Rezoning Transportation Analysis

Petition Number: #2022-107

Date	Description
11-28-22	First Review (IW)
12-22-22	Second Review (DR)

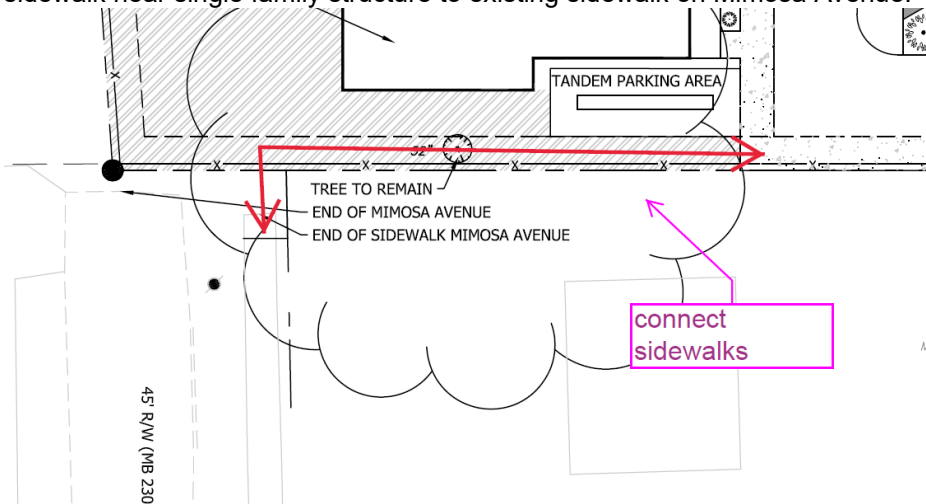
1. **Curbline:** The proposed zoning district has a setback measured from back of the existing or proposed future curbline.
 - a. **Parkwood Avenue:** Location of curb and gutter is 38 feet from centerline.

Outstanding Comment from 11-28-22 Label and dimension the curb and gutter from the centerline for each road on the site plan.

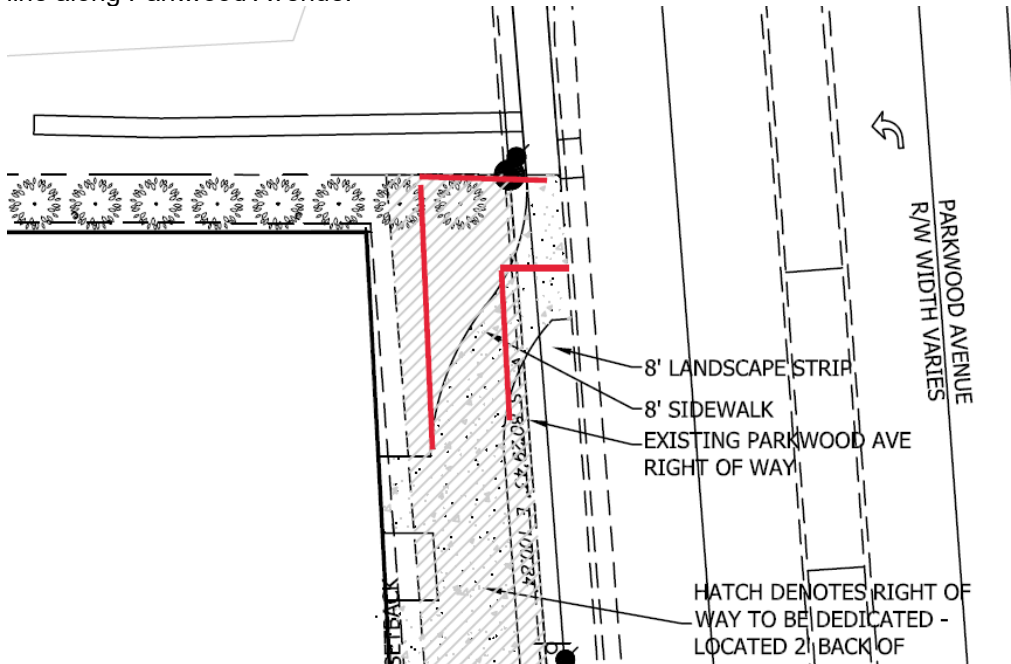
3. **Outstanding Comment from 11-28-22** Revise site plan and conditional note(s) to commit to dedicate 56 feet of right-of-way from the road centerline. The site plan shall label and dimension the right-of-way from the road centerline.
4. CDOT requests the site plan and conditional note(s) revisions are needed to commit to connect sidewalk near single family structure to existing sidewalk on Mimosa Avenue.

Clarifying comment from 12/22/2022: Commit to connect sidewalk near single family structure to existing sidewalk on Mimosa Avenue as shown above.

5. Site plan and conditional note(s) revisions are needed to commit to extending the 8' sidewalk to property line along Parkwood Avenue.

Clarifying comment from 12/22/2022: Extend 8-foot sidewalk as shown above to property line along Parkwood Avenue.
